HISTORIC AND DESIGN REVIEW COMMISSION

October 19, 2022

HDRC CASE NO: 2022-513
ADDRESS: 400 CLUB DR
LEGAL DESCRIPTION: NCB 7013 BLK LOT 9
ZONING: RM-4, H
CITY COUNCIL DIST.: 7
DISTRICT: Monticello Park Historic District
APPLICANT: Paul Zurita/Zurita Construction & Remodeling
OWNER: IDEA INTERNATIONAL LLC
TYPE OF WORK: Window replacement
APPLICATION RECEIVED: October 04, 2022
60-DAY REVIEW: Not applicable due to City Council Emergency Orders
CASE MANAGER: Jessica Anderson

The applicant requests a Certificate of Appropriateness for approval to replace the existing metal casement windows with wood windows and to replace the wood garage doors with an aluminum panel garage door.

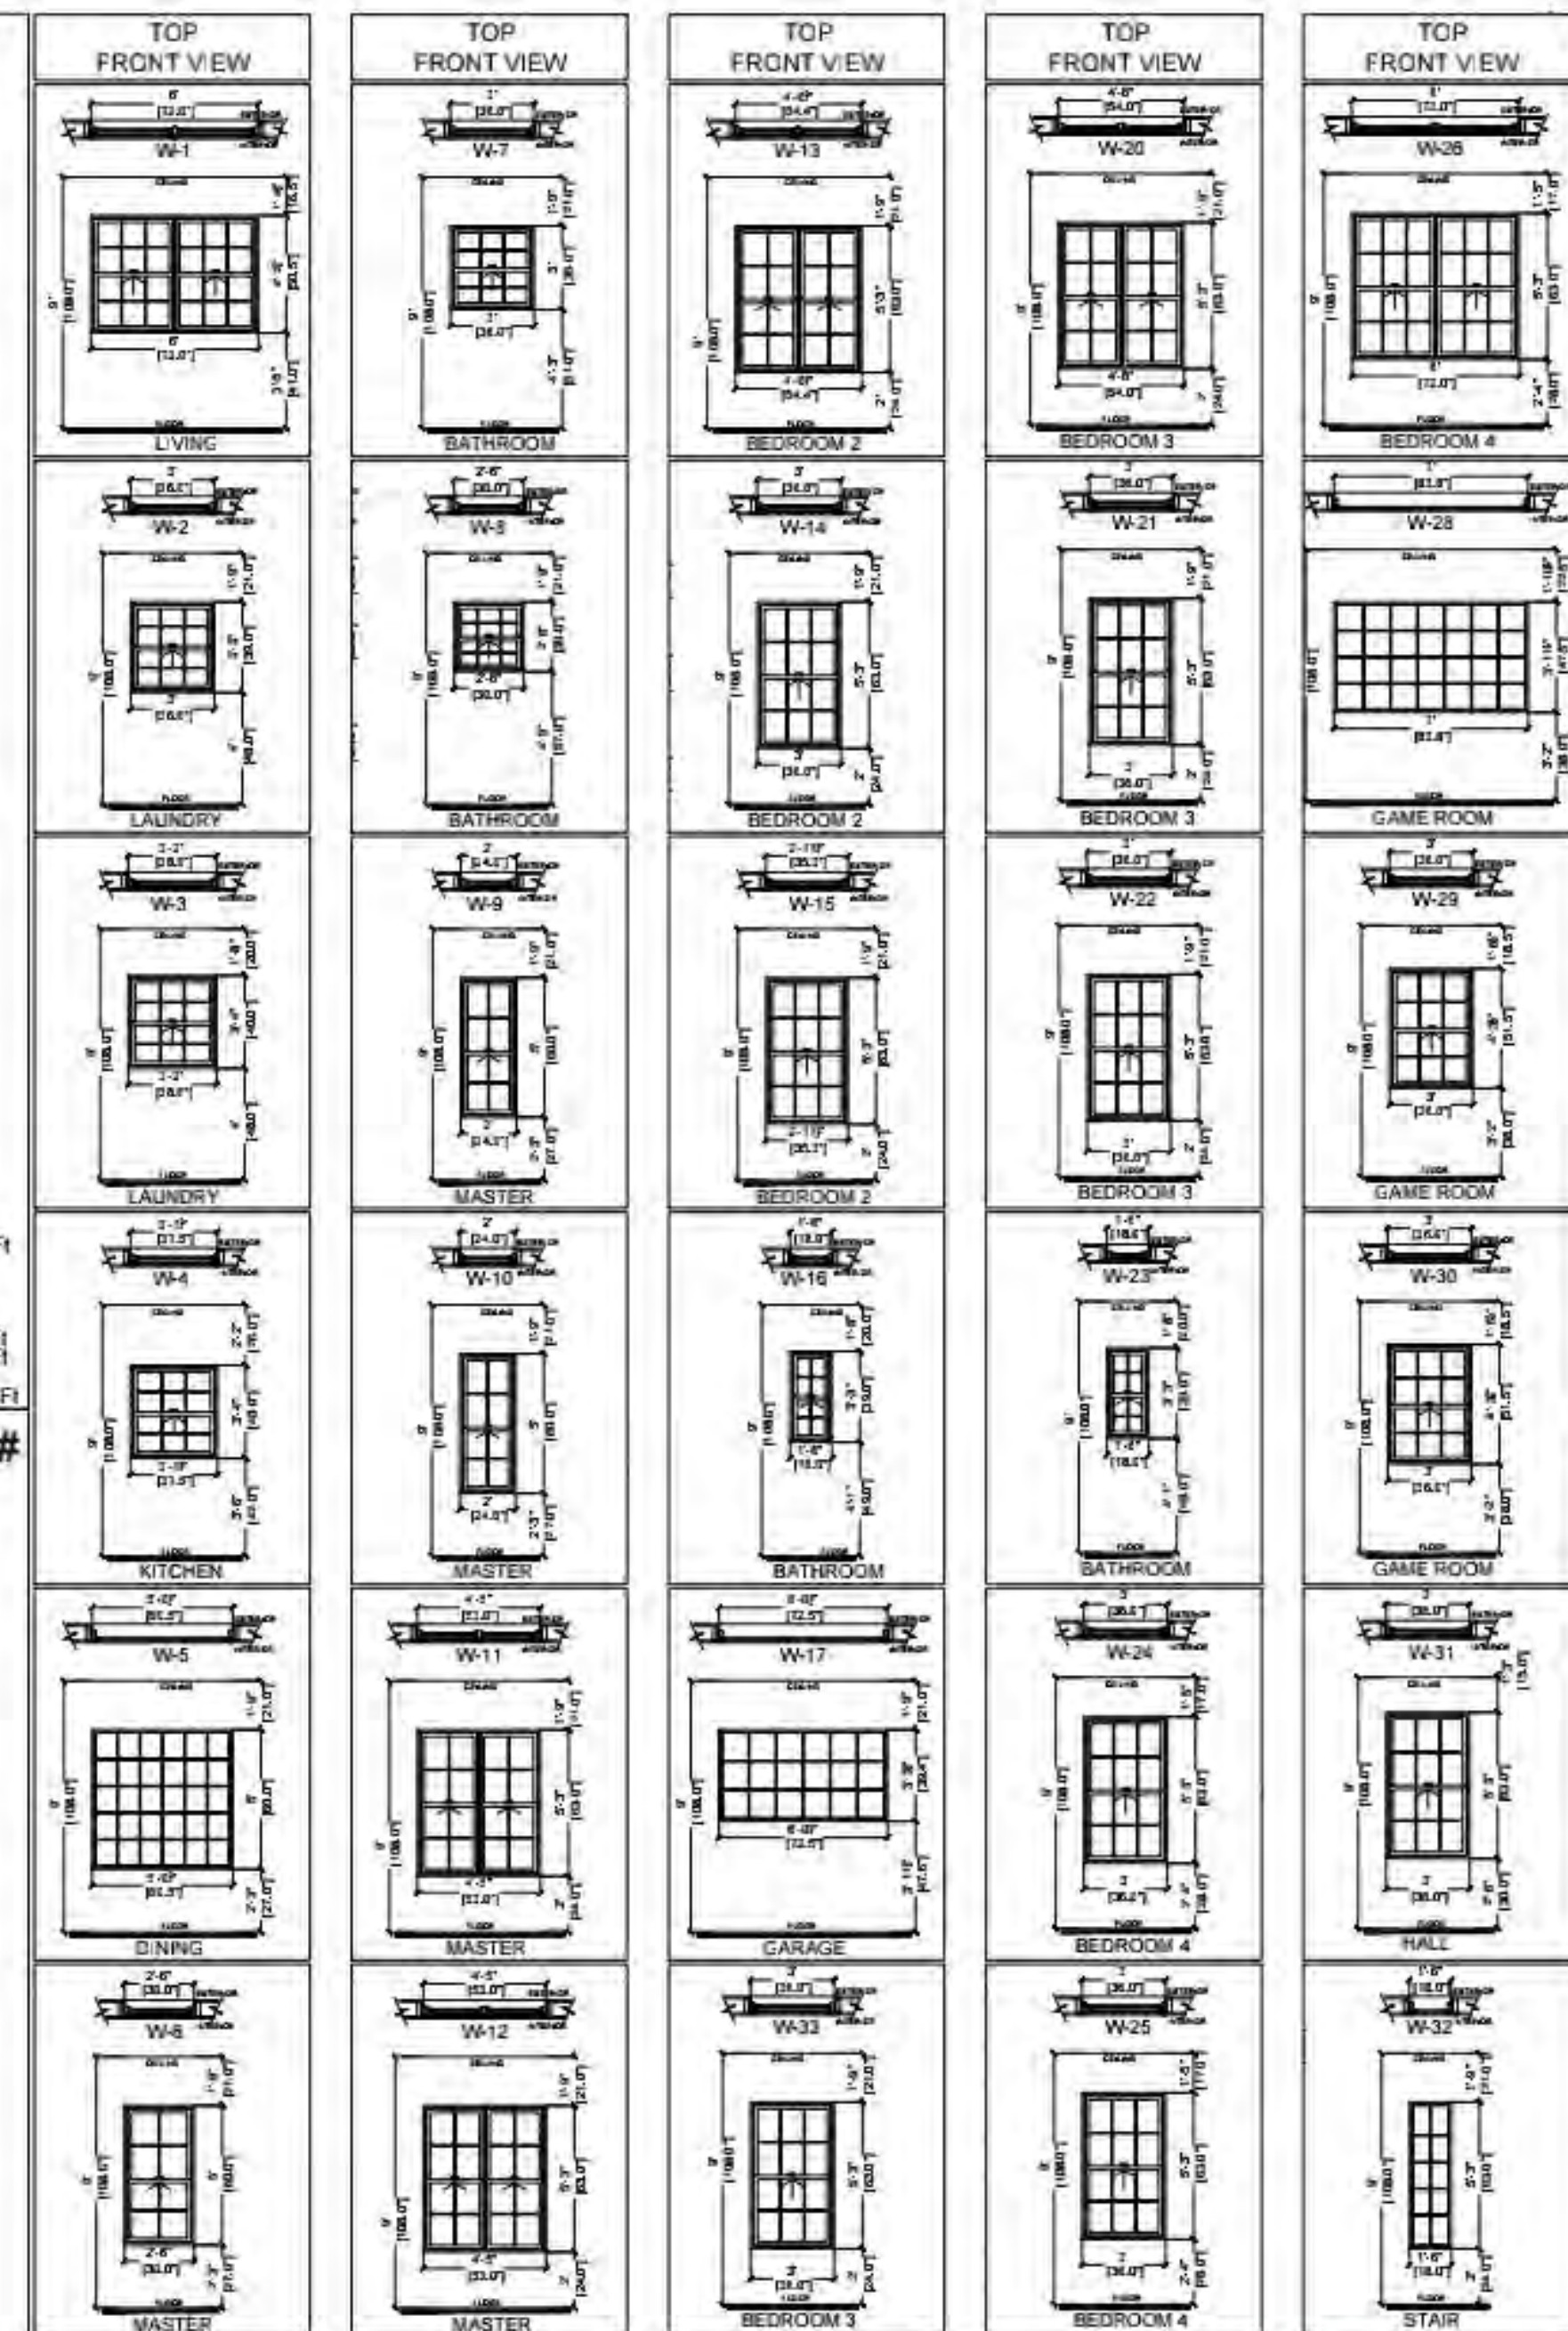
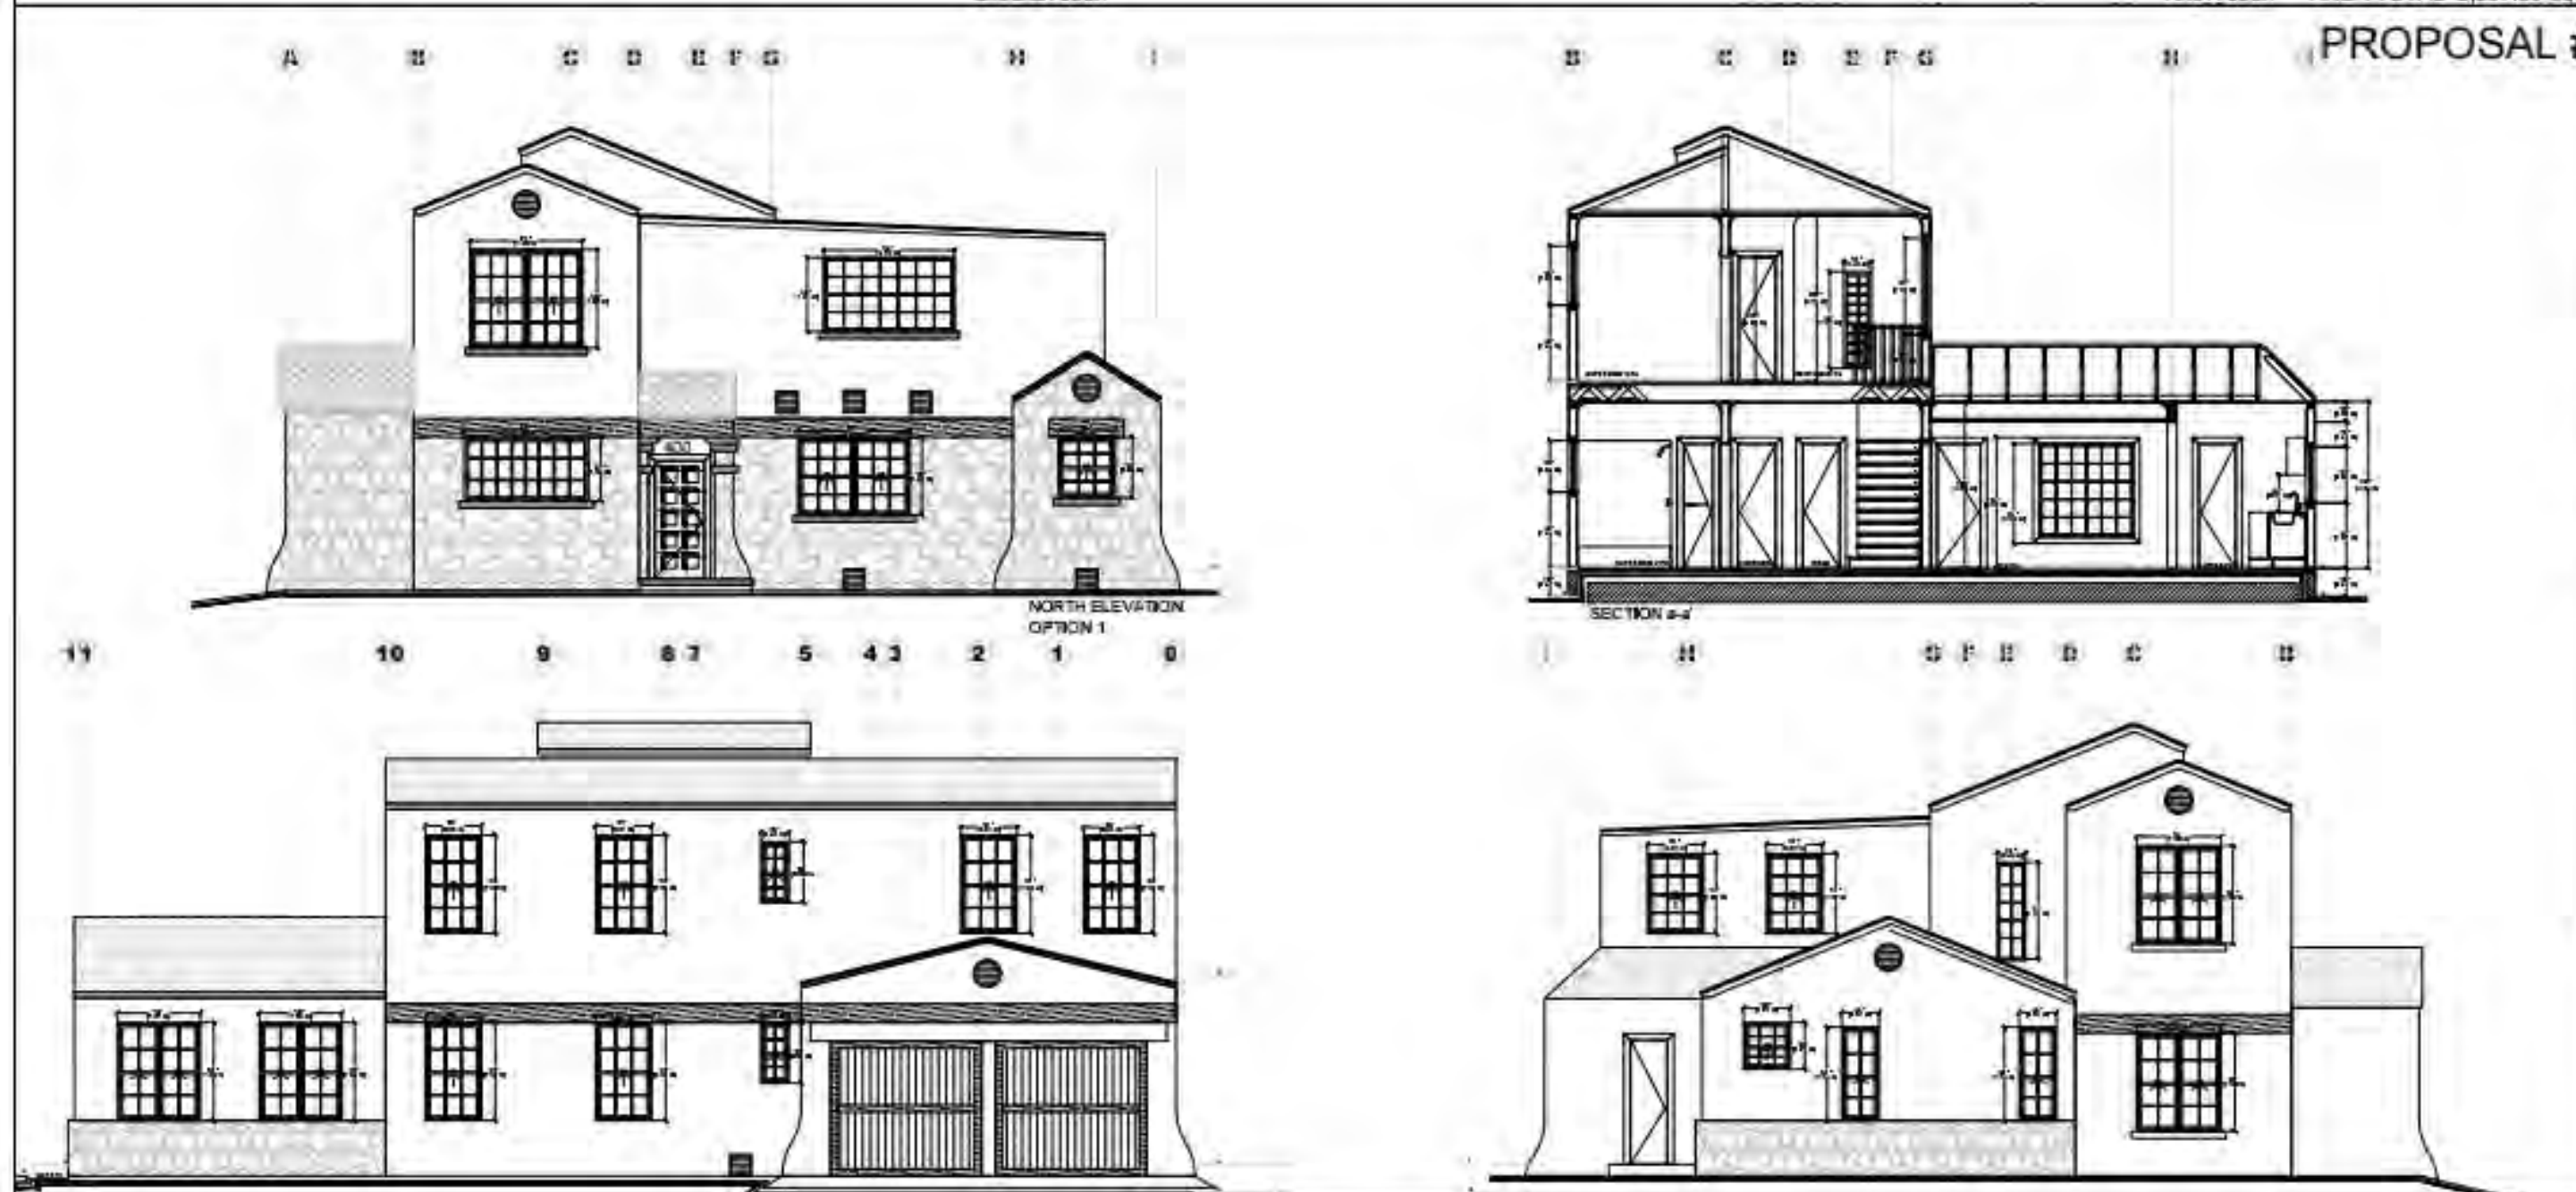
- c. **WINDOW REPLACEMENT:** The applicant requests to replace existing metal casement windows with aluminum-clad wood windows. Staff finds the request generally appropriate, but recommends the windows feature true divided lights without false muntins. Staff also recommends retention of the existing window dimensions as well as retention of the prominent lintels found above some of the first-story windows.

- d. **GARAGE DOORS:** The applicant requests to replace the existing wood garage doors with an aluminum panel door. Historic Design Guidelines for Exterior Maintenance and Alterations 9.B.i says to ensure replacement of garage doors are compatible with those found on historic garages in the district as well as with the principal structure. Staff finds the proposed aluminum garage door does not conform to guidelines. Per Guideline 9.B.i, since the garage is visible from the right-of-way, staff recommends a door compatible with those found on historic garages in the district, namely a wood-paneled door.

- 1. We were in the process of repairing the windows and we found the wood has rotted out in the majority of the windows and all need to be replaced with new windows. We will be replacing with aluminum windows with wood and wood frame, which the wood will be painted to match existing.**
- 2. We would also like to install a new Aluminum Garage Door (1 door in place of 2) we have attached a pic where the opening of the garage door will be placed with a new wood frame that will be painted to match the existing.**

Staff recommends approval of the request to replace metal casement windows with aluminum-clad wood windows based on finding c, with the following stipulations:

- i. That the windows feature true divided lites without false muntins.
- ii. That new windows retain the existing window dimensions.
- iii. That prominent lintels over first-story windows be retained where they are found.

Staff recommends approval of the request to replace the existing wood garage doors based on finding d, with the following stipulation:

- i. That the applicant propose a wood paneled garage door that conforms to guidelines.
